## PIC32MZ Embedded Connectivity with Floating Point Unit (EF) Family Silicon Errata and Data Sheet Clarification

The PIC32MZ Embedded Connectivity with Floating Point Unit (EF) family of devices that you have received conform functionally to the current Device Data Sheet (DS60001320), except for the anomalies described in this document.

**FIGURE 1: Posc CRYSTAL CIRCUIT**

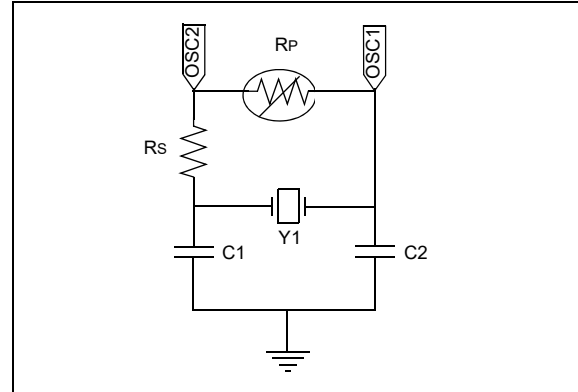
**Revision A3 and B3 Silicon:** The Posc has been tested in a normal power-up sequence and supports specific crystal operation.

The Primary Oscillator (Posc) has been characterized to operate at 8 MHz, 12 MHz, and 24 MHz when the circuit in [Figure 1](#) is implemented, and the operating conditions listed in [Table 3](#) are met.

### 64-PIN QFN<sup>(4)</sup> AND TQFP (TOP VIEW)

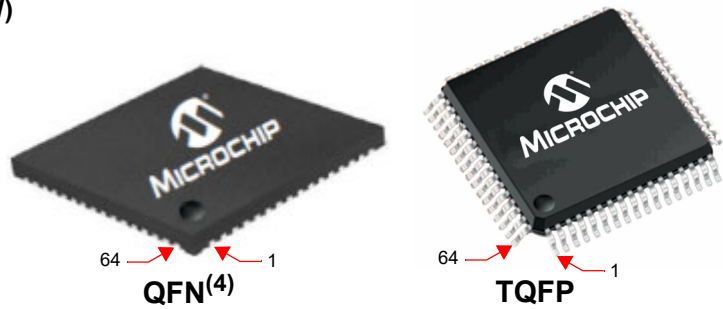
In Table 2. “Pin Names for 64-pin QFN and TQFP Devices” of the current data sheet, the AECRSRV signal was erroneously omitted from the pin number 44 and added to the pin number 62. The correct assignment is shown in bold type in the following table.
